**SUBDIVISION, PLANNED UNIT DEVELOPMENT
& SIDEWALK WAIVER STAFF REPORT****Date: March 6, 2008****APPLICANT NAME**

U. S. Machine Subdivision

LOCATION576 and 600 Zeigler Circle East
(Southeast corner of Zeigler Circle East and Sellers Lane).**CITY COUNCIL
DISTRICT**

Subdivision approval to create 1 lot, Planned Unit Development approval to allow multiple buildings on a single building site and sidewalk waiver to waive the construction of sidewalks along Zeigler Circle East and Sellers Lane.

SITE PLAN

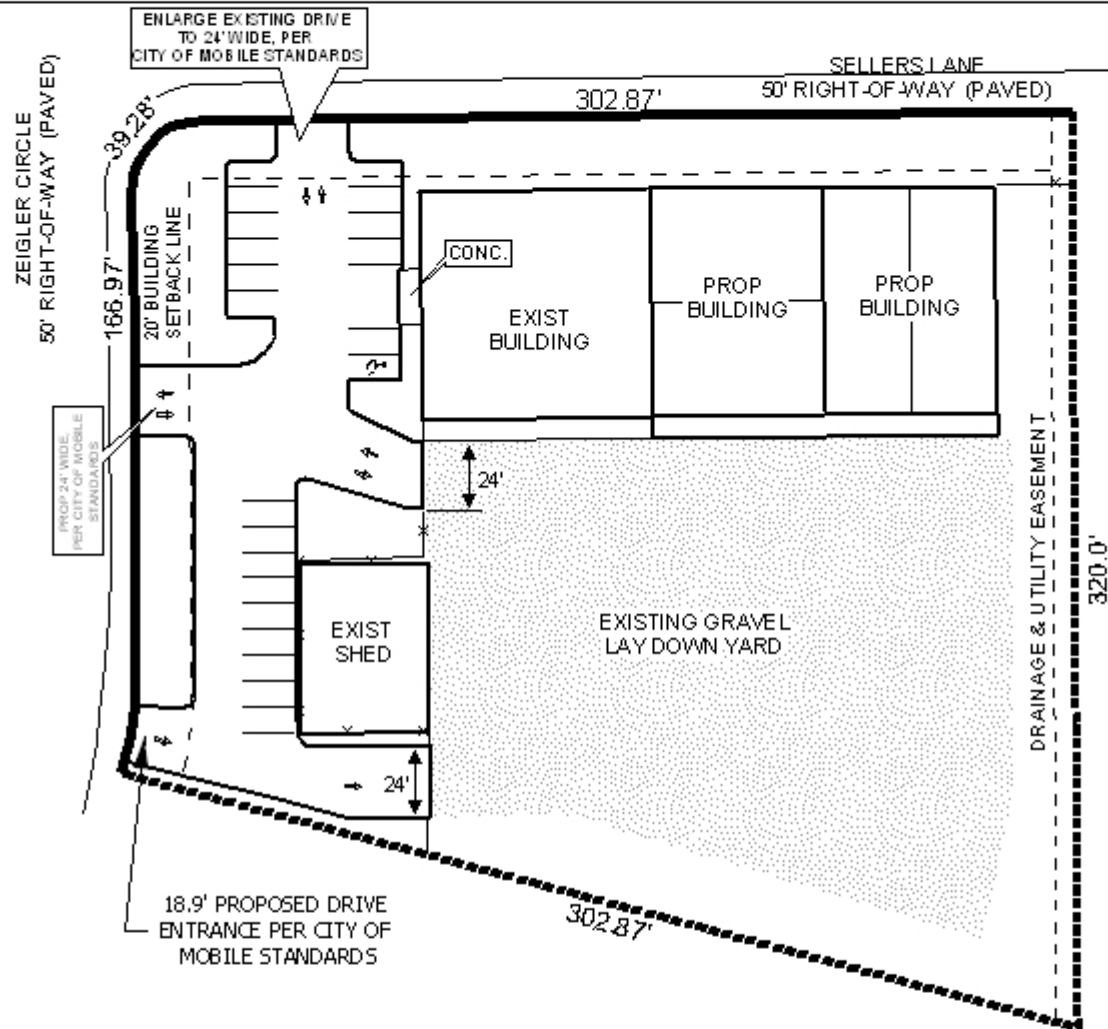
way drive. Ninety degree parking stalls require a twenty-four foot aisle width. To accommodate the seventeen foot one-way that is shown, the parking stalls should be changed to angle parking.

There are a few issues relating to the site plan submitted, the applicant has not addressed all points in determining the design of the expansion to the site. The applicant illustrates 21 asphalt parking spaces; however, does not break down the parking requirements for the site (one space per 300 square feet for office use and 1 space per 3 warehouse or fabrication workers on the site. The site plan submitted exceeds the minimum landscaping and tree requirements and should be approved as submitted. The applicant also illustrates the gravel laydown yard; therefore, a surface variance would also be required to allow this type of surface to remain or the Commission may approve the Planned Unit Development as proposed.

- 1) completion of the Subdivision process;
- 2) the submission of a revised PUD site plan reflecting compliance with the parking requirements of the Zoning Ordinance;
- 3) the approval of the use variance from the Board of Adjustment;
- 4) full compliance with all other municipal codes and ordinances.

CROSS SECTION DETAIL

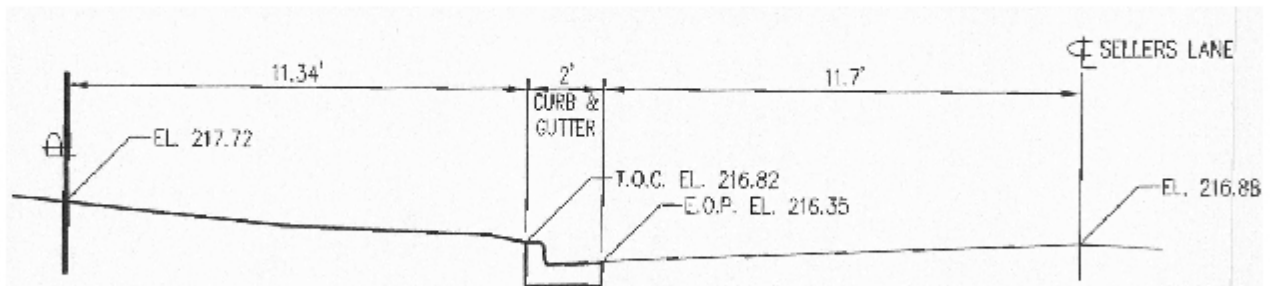
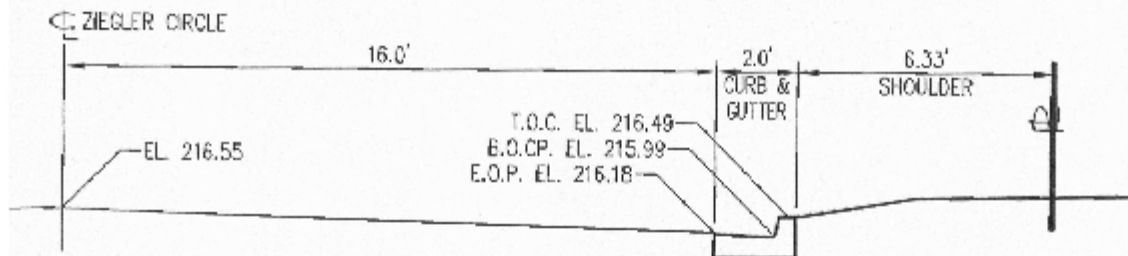
Sidewalk waiver: Need additional backup information on existing conflicts in the area to substantiate sidewalk waiver.

As Engineering Department states the applicant needs to submit additional backup information on existing conflicts in the area to substantiate sidewalk waiver.

Sidewalk Waiver: Based upon the preceding, this application for waiver of the sidewalk along Zeigler Circle East and Sellers Lane should be heldover until the April 3rd meeting with any documentation to be submitted no later than March 10th, for the following reasons:

- 1) due to the presence of undeveloped properties in the immediate area; and
- 2) submission of additional backup information on existing conflicts in the area to substantiate sidewalk waiver.
